Subject: VARIOUS ELECTRICAL SYSTEM MALFUNCTION(S) RELATED TO C-15 CONNECTOR CORROSION	Bulletin No: 09-005/14
	Last Issued: 02/07/2014

2013-2014 CX-5 vehicles with VINs lower than JM3KE*****365953 (produced before June 25, 2013)

MASS PRODUCTION CHANGES:

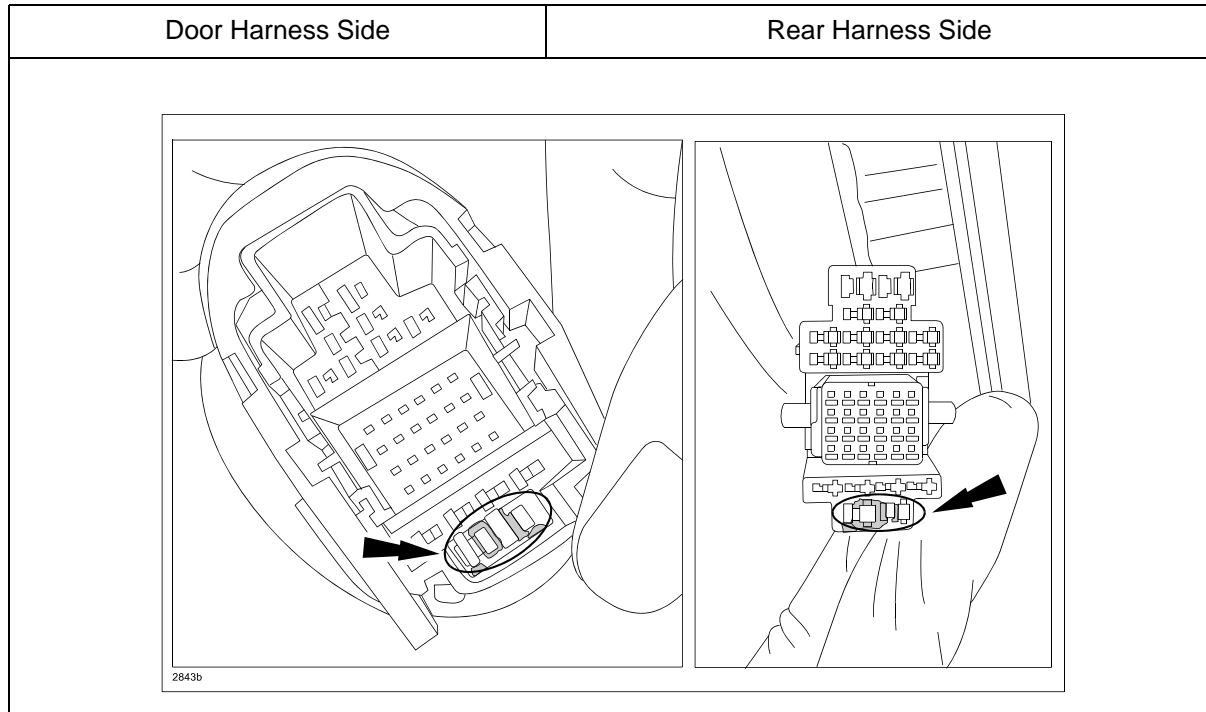
- The front door harness grommet has been changed to improve sealing performance.
- Holes inside the front pillar (which are made for weight reduction), have been covered to prevent water intrusion.
